Reference: 23.464r03v02

**RE Proposed Construction and Demolition (C & D) Waste Management Facility (SSD-62855708)
Response to Goodman Submission**

TRAFFIX has reviewed all relevant comments from a traffic engineering /parking perspective and has responded to each issue below. This is with reference to the updated Traffic Impact Assessment (TIA) report (TRAFFIX Reference: 23.464r01v12) dated December 2024.

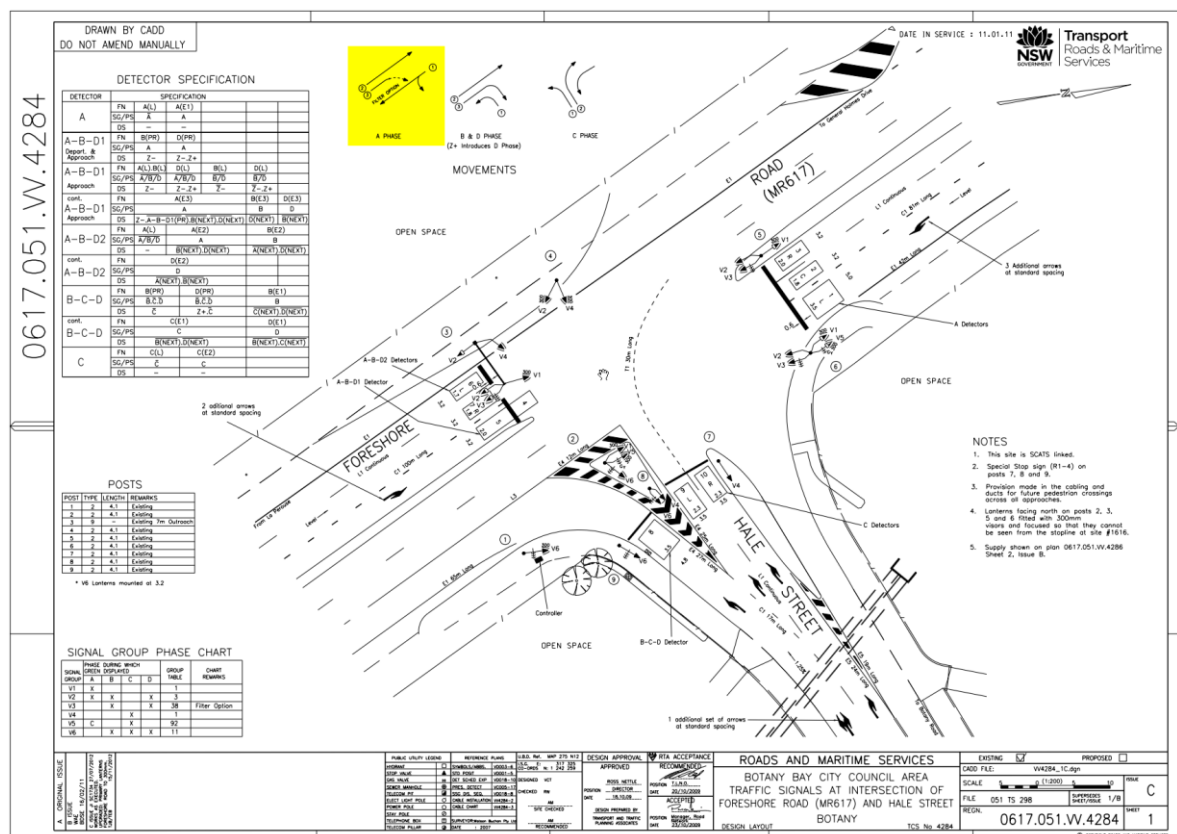
- The base case model indicates Level of Service (LOS) A for peak hours at the Foreshore Road/Hale Street intersection, suggesting minimal delays. However, discrepancies in queue lengths question the accuracy of this depiction.
- Modelled signal control allows a 'filtered' right-turn from the south during Phase A, raising concerns given the 80 km/h speed limit on Foreshore Road and the need to filter across three lanes. The TCS plan does not support a 'filtered' right-turn.

Signal phasing has been set up in accordance with TCS No. 4284 (REGN. 0617.051.W.4284) showing a right-turn filter option for Foreshore Road in Phase A, reproduced in **Figure 1** below.
